Target Fine-wear Industries Ltd. (9529)

Alauddin Chowdhury Tower, out para, Chandona Chowrasta, Joydebpur , Gazipur

11.MAY.2014

Identified Priority 1 Concerns

1st Priority 1 Concern

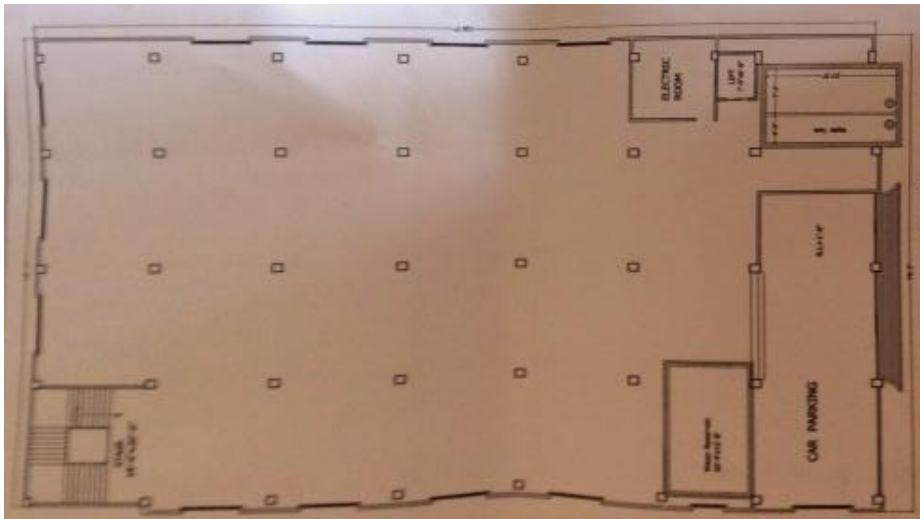
As per as-built drawing and the confirmed from design engineer, there are no shear links provided to resist the shear force at the column joint.

As per our calculation for punching shear at the typical column, the shear stress at the first perimeter is higher than the design concrete shear stress. Based on the code, this is not satisfied for the slab thinner than 200mm.

The span/depth ratio for flat slab which controls the limit of deflection for an RC element is defined apparently as $L/30$. The ratio for 6.09m span and 178mm thickness slab is 34 which was higher than ratio requirement. Thinner flat slab will lead to increase the deflection in short-term and long-term and reduce the punching shear resistance as well.

A flat slab system with insufficient punching shear will have the potential to fail without warning, which will cause the whole building to collapse.

The structural drawings also appear to represent incorrectly detailed flat slab rebar arrangement.

Item No.	Observation	Recommended Action Plan	Recommended Timeline
1	The flat slab is not sufficient to resist the punching shear force.	Limit the average imposed load on the floor to a maximum of 1.5kPa (30 psf)	Immediate – Now
2	The flat slab is not sufficient to resist the punching shear force.	Carry out intrusive testing of the structure to determine the actual concrete strength, rebar strength and rebar layout	6-weeks
3	The flat slab is not sufficient to resist the punching shear force.	Carry out the strengthening work to increase the punching shear capacity Carry out the strengthening work to provide the lateral load resistance system	6-months
4	The raised floor at level 4 exceeds the design finish and live load	Limit all live load in this area to the absolute minimum. Consider relocating some of the machines	Immediate – Now
5	The raised floor at level 4 exceeds the design finish and live load	Consider removing the raised floor, or constructing raised floor from lightweight fill, such as lightweight concrete or lightweight concrete block	6-weeks

2nd Priority 1 Concern

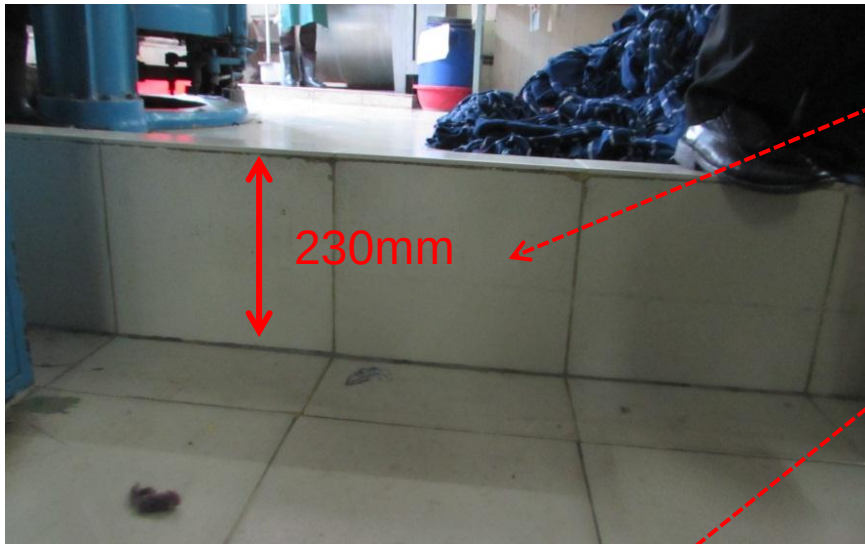
Raised floor with 180mm sand filling and 50mm screed and tile

Industrial machine with a total operating weight exceeding 650kg

The raised floor has been built on level 4. However, the loading from the raised floor was not considered in the structural design. The design finish load was only assumed to be 1.2kPa, whilst the raised floor finishes has been assessed to be approximately 3.24kPa. In addition, the individual washing machine weight of 650kg with the dimension 1.75m x 1.35m, exerts a loading of more than 4kPa, which exceeds the design live load of 2.87kPa

6	The raised floor at level 4 exceeds the design finish and live load	Introduce strengthening works under the slab (such as a steel beam support system) which can direct loads directly to the columns, and reduce loading burden to the slab.	6-months
